PIC18C658/858 Rev. B1 Silicon/Data Sheet Errata

The PIC18C658/858 parts you have received conform functionally to the Device Data Sheet (DS30475A), except for the anomalies described below.

FIGURE 1: PIC18CXX8 VOLTAGE-FREQUENCY GRAPH (INDUSTRIAL, EXTENDED)

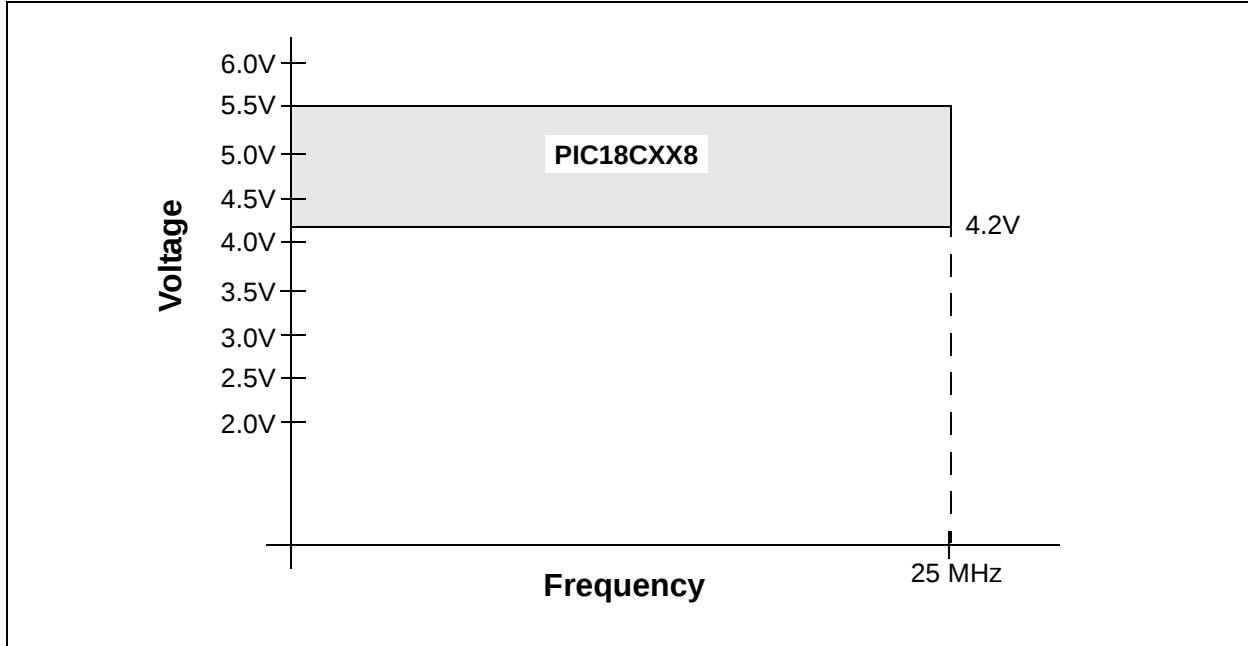
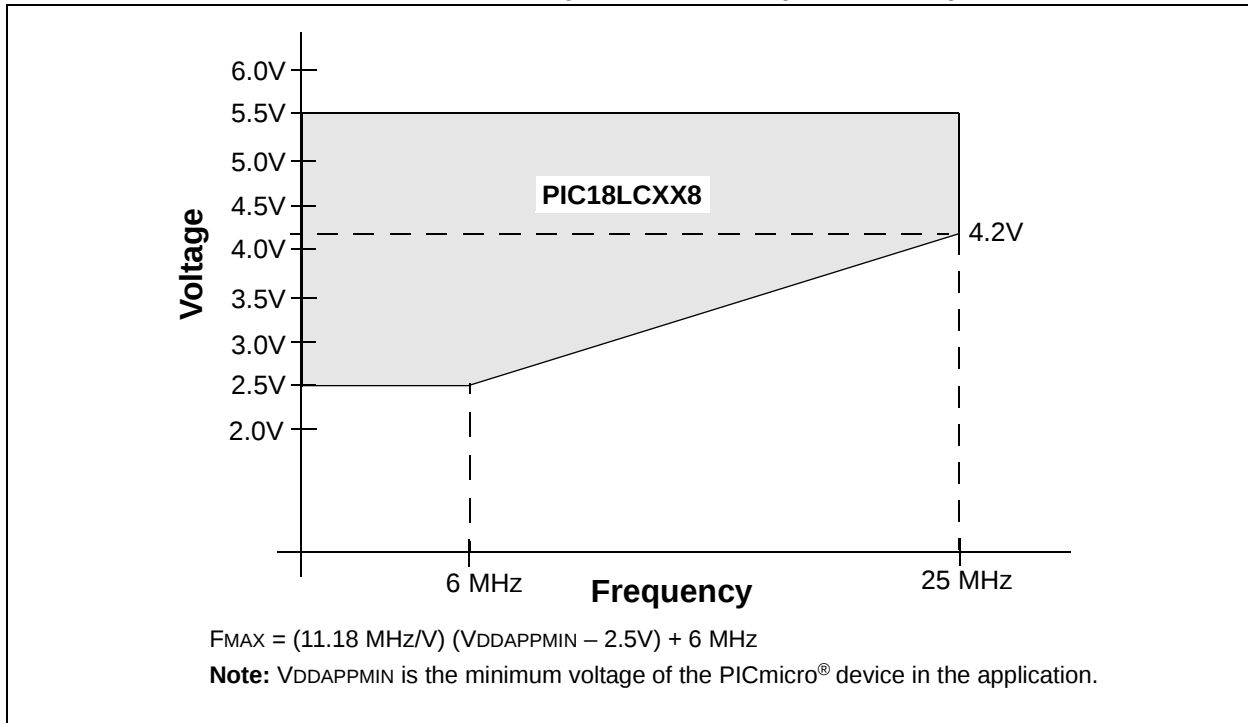
12. Module: Core (Voltage vs. Frequency)

The device may not operate properly at frequencies exceeding 25 MHz. The graphs in Figures 1 and 2 show the expected voltage vs. frequency operating range for standard voltage range and extended voltage range devices, respectively.

Work around

None. This issue is expected to be resolved in a future silicon revision. Please contact a Microchip sales office for additional information on availability.

FIGURE 1: INTERRUPT LOGIC (EXCERPT)

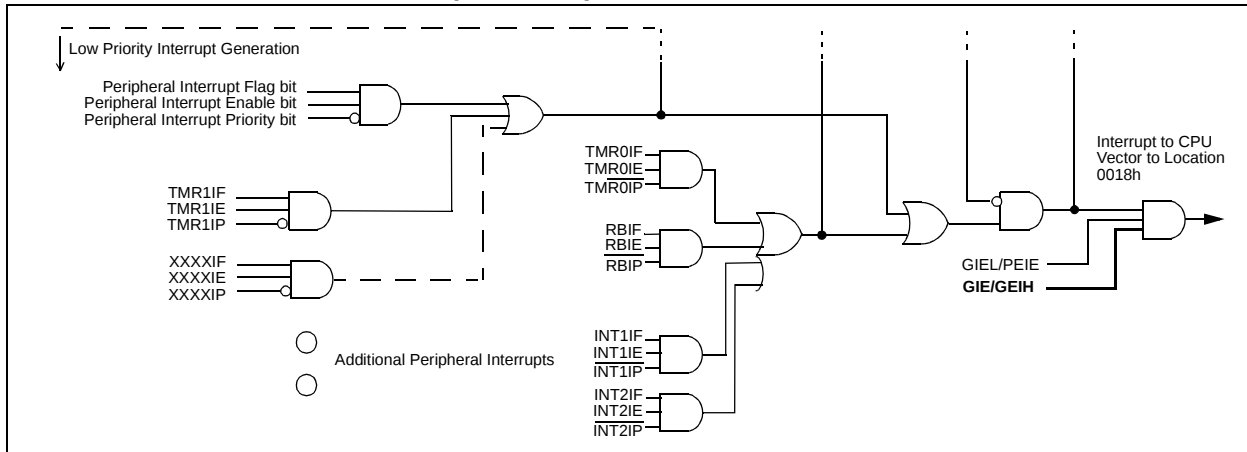
Also, the interrupt logic funnel shown in Figure 7-1 of the Device Data Sheet is amended with the addition of a GIE/GIEH control line, as shown in Figure 1 (new material in **bold line**).
